RENESAS TECHNICAL UPDATE

Product Category	MPU & MCU	Document No.	TN-16C-A212A/E	Rev.	1.00
Title	Errata to R32C/117A Group User's Manual: Hardware	Information Category	Technical Notification		
Applicable Product	R32C/117A Group	Lot No.	Reference Document	R32C/117A Group User's Manual: Hardware Rev. 1.00 (REJ09B0576-0100)

This document describes corrections to the R32C/117A Group User's Manual: Hardware, Rev. 1.00. The corrections are indicated in red in the list below.

Figure 8.1 Clock Generation Circuitry

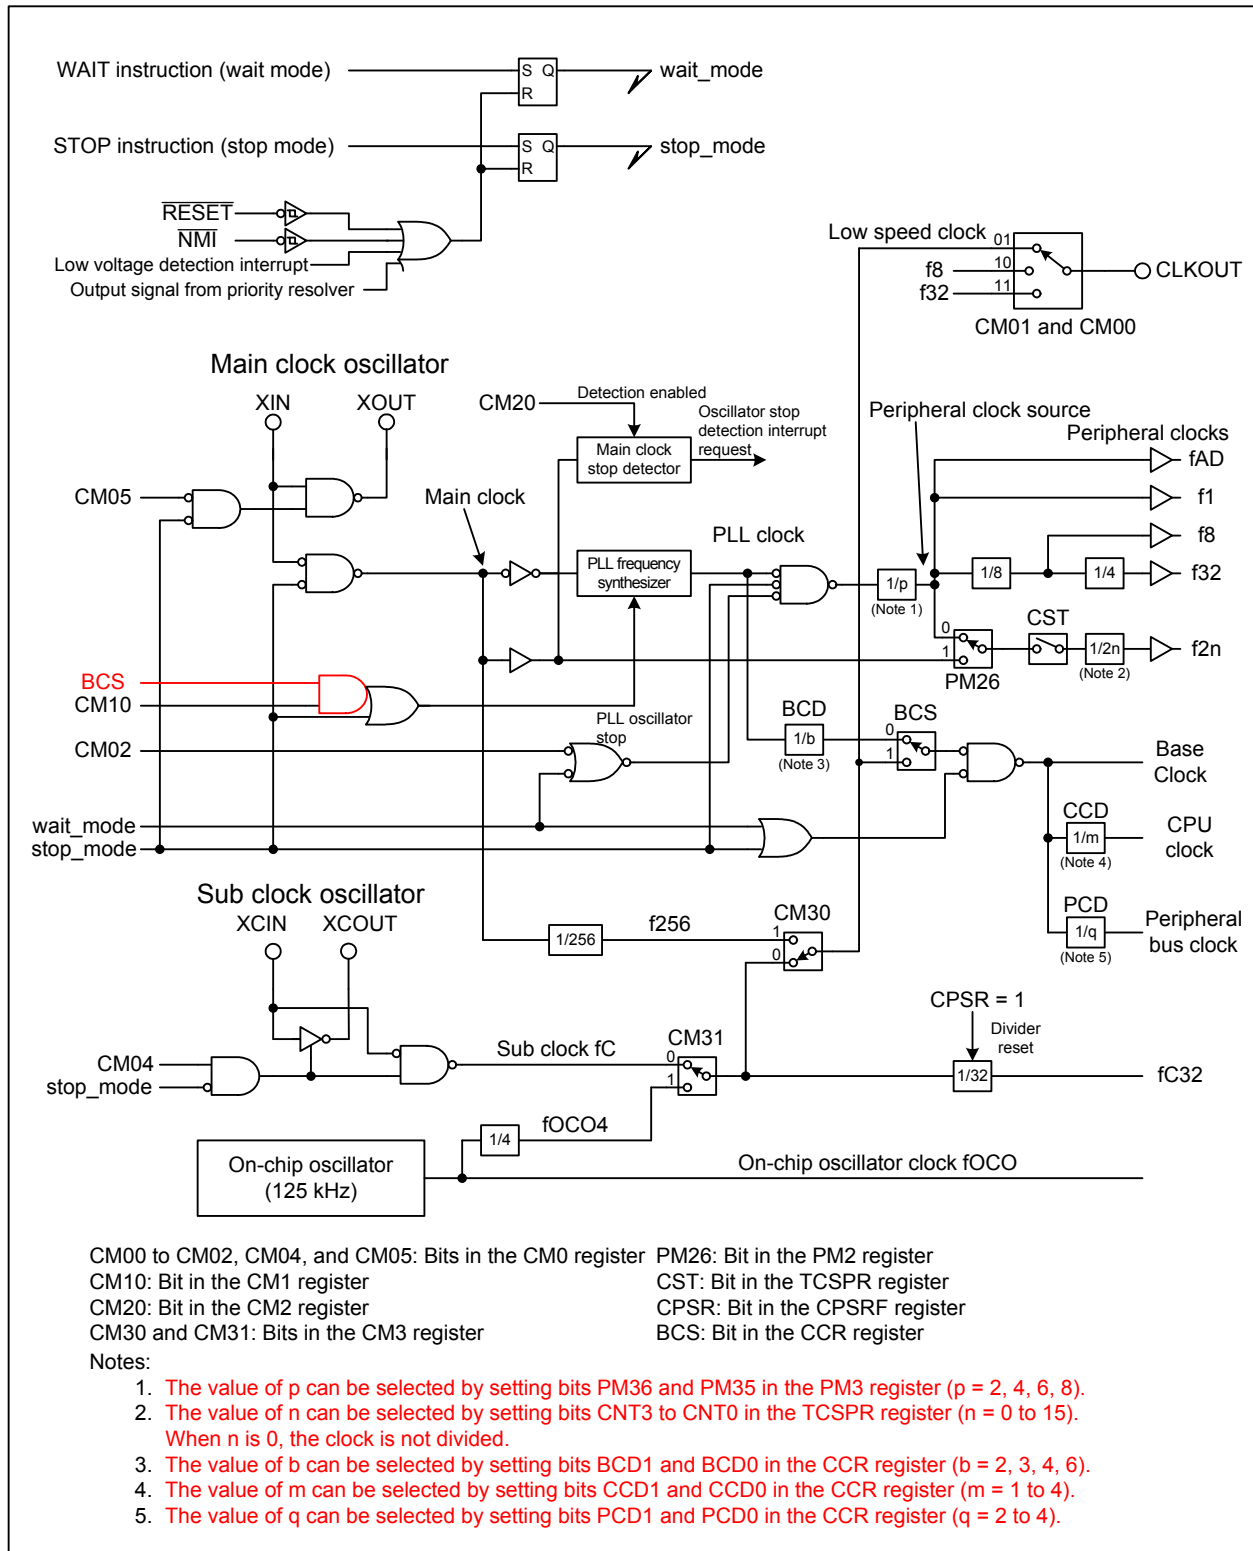
•Page 86 of 625, Figure 8.1 is corrected as follows:

Figure 21.1 CRC Calculator Block Diagram

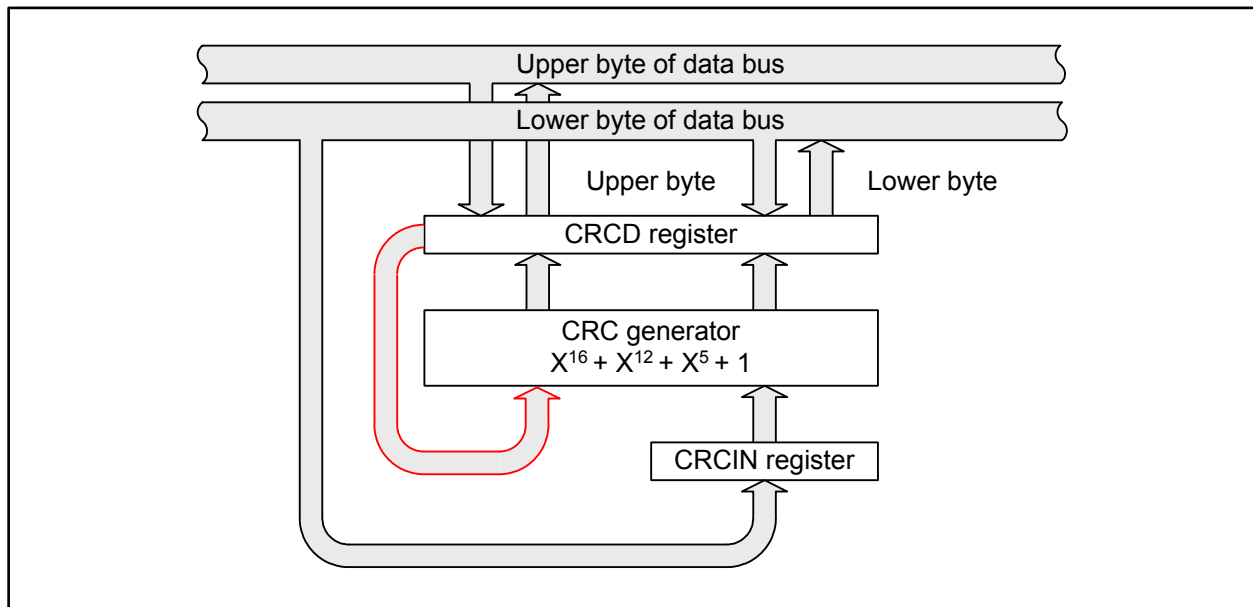
- Page 319 of 625, description in 19.1.5 is modified as follows:
 “In repeat sweep mode 1, the analog voltage applied to eight selected pins including **one to four** prioritized pins is repeatedly converted into a digital code. Table 19.6 lists specifications of repeat sweep mode 1.”
- Page 319 of 625, description for the function in Table 19.6 is modified as follows:
 “**The analog voltage applied to eight selected pins including one to four prioritized pins is repeatedly converted into a digital code. The prioritized pins are selected by setting bits SCAN1 and SCAN0 in the AD0CON1 register and bits APS1 and APS0 in the AD0CON2 register**”
- Page 328 of 625, description “AD0i register” in the ninth bullet point of 19.3.2 is modified as follows:
 “**AD00 register**”
- Page 331 of 625, Figure 21.1 is corrected as follows:

Figure 27.1 Typical I/O Pin Block Diagram (i = 0 to 19; j = 0 to 7)

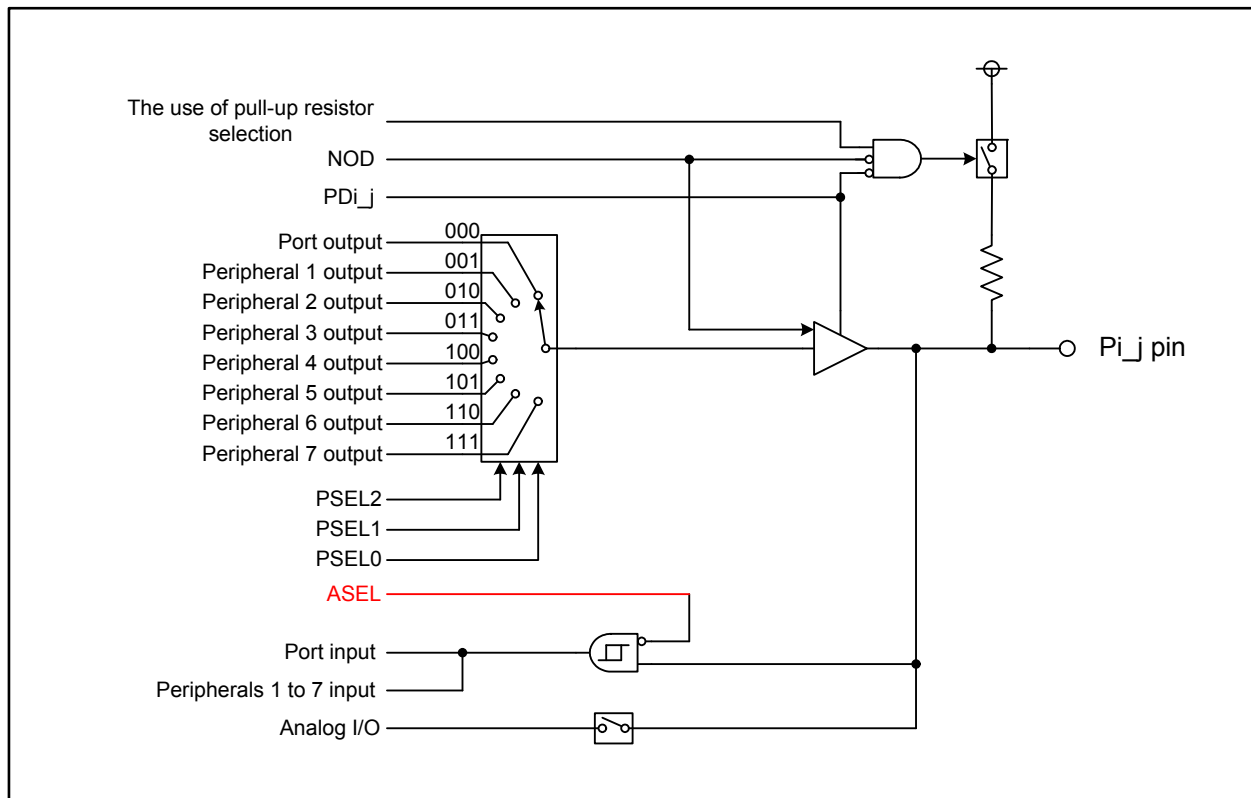
- Page 487 of 625, Figure 27.1 is corrected as follows (refer to TN-16C-A200A/E):
